MEMORANDUM

SUBJECT: Waiver of Site Plan Approval – 116 Woodruff Street

DATE: December 7, 2021

Re: Site Plan Waiver Application Construction Staging Area Samaritan Medical Center (A&C #2015-174.008) 116 Woodruff Street, Watertown, NY

SITE DEVELOPMENT PLAN

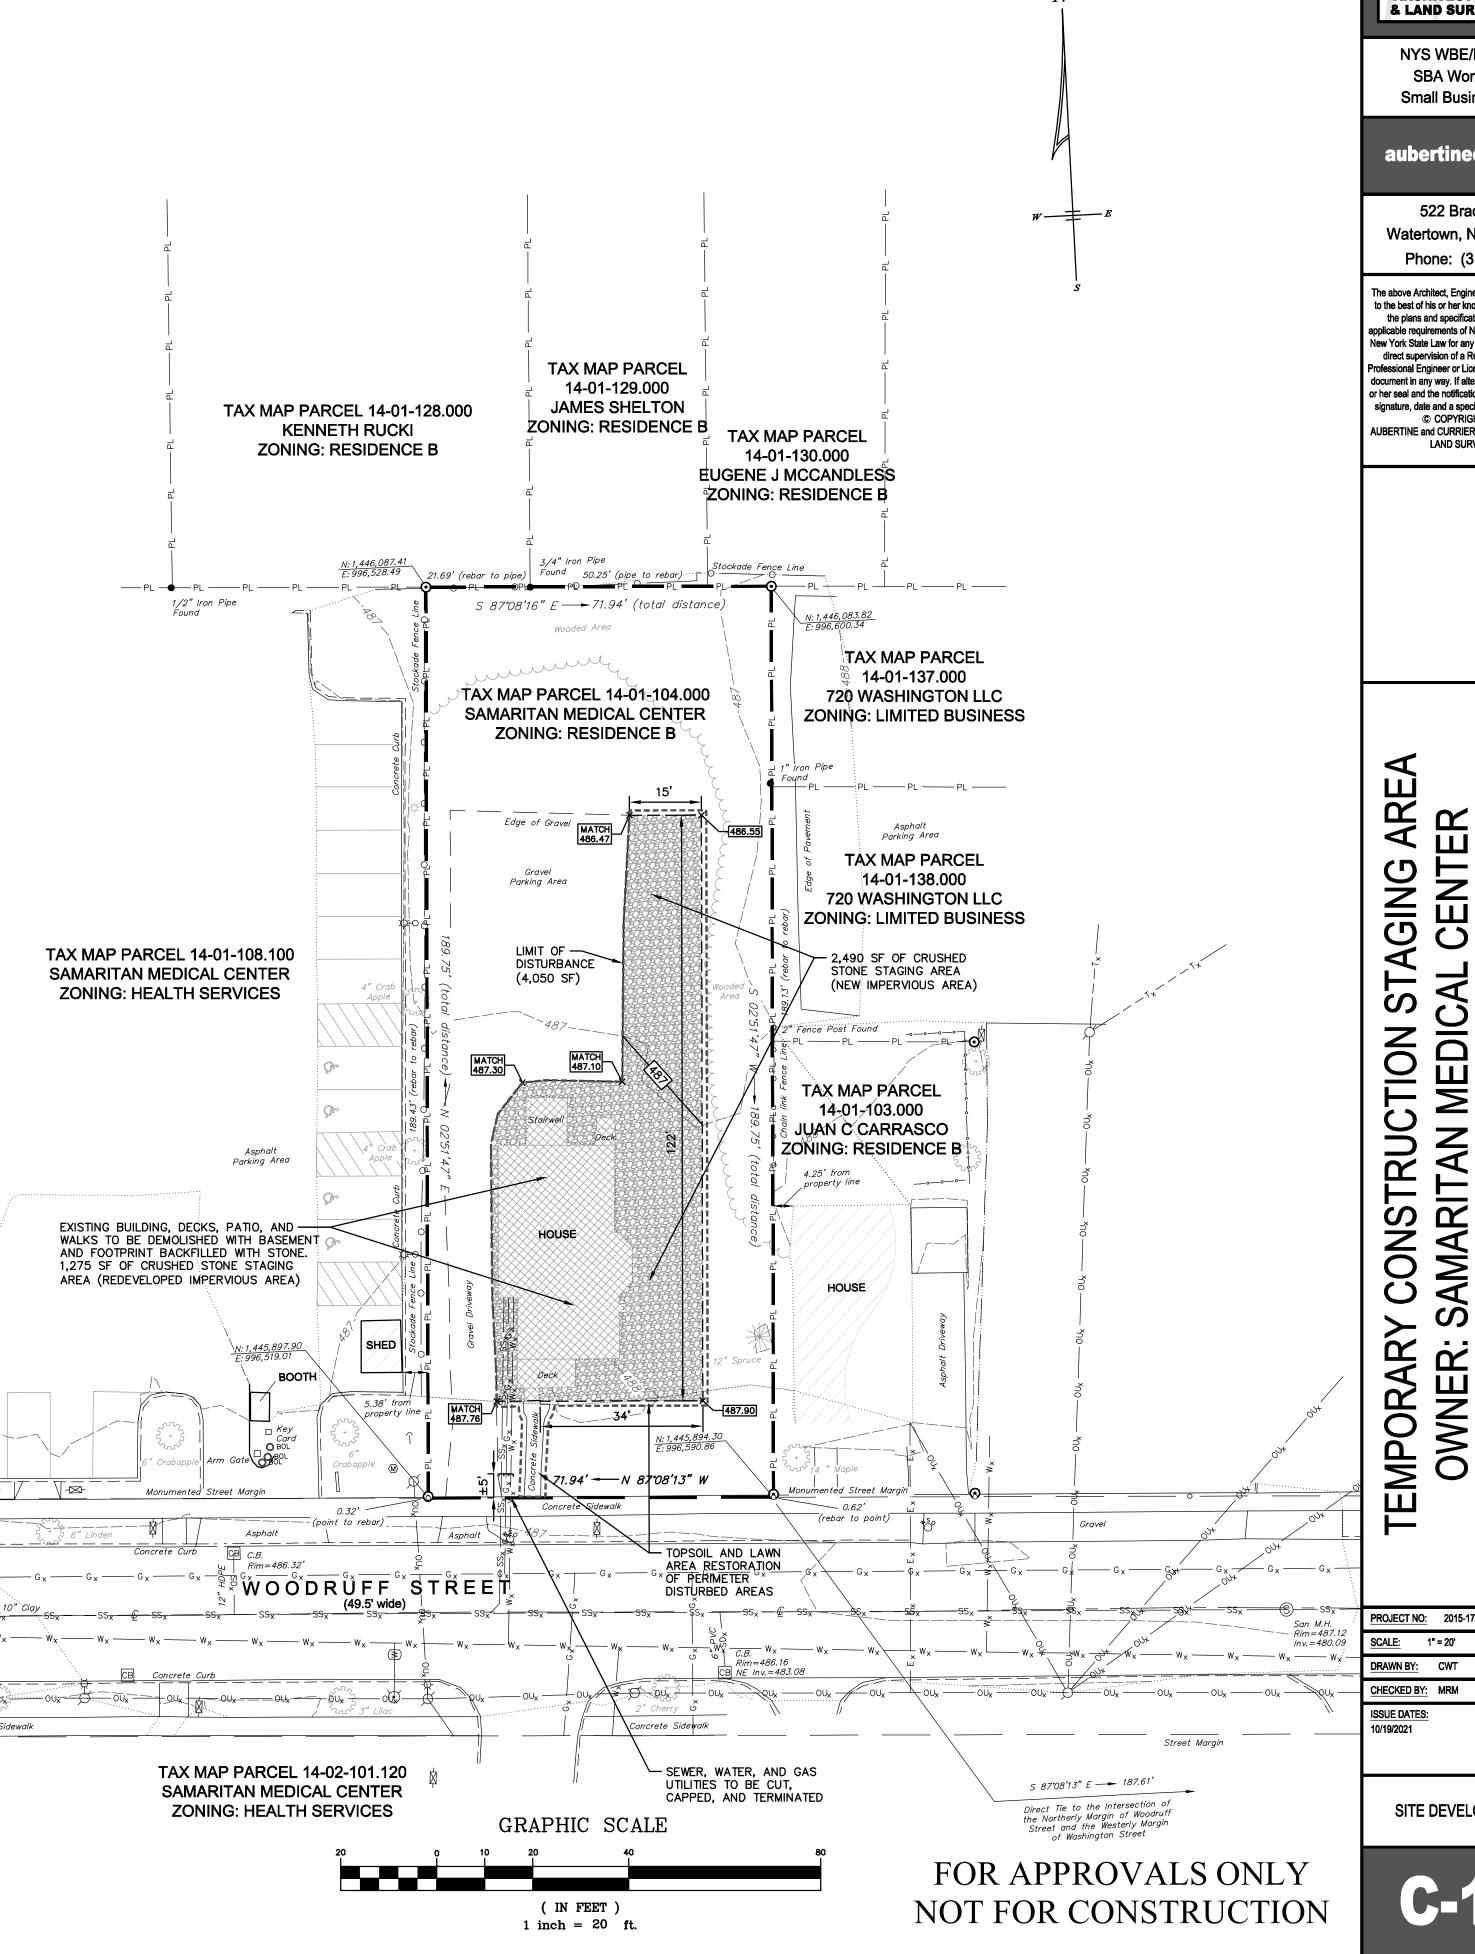
Application Synopsis and Case Review: The applicant proposes to demolish the existing vacant residential structure on the site and lay down 2,490 SF of crushed stone in its place. The applicant's cover letter states that Samaritan Medical Center (SMC) plans to use the area "for construction material staging and storage." While the proposal would repurpose over 4,000 SF in land, the Planning Board determined at its November 2, 2021 meeting that the project was eligible for a Waiver because the aggregate building and parking area coverage would not increase by over 2,500 SF and the proposal met the criteria for Waiver eligibility, as stated in the Zoning Ordinance.

1. The applicant must locate and mark all utilities prior to the issuance of a Demolition Permit.
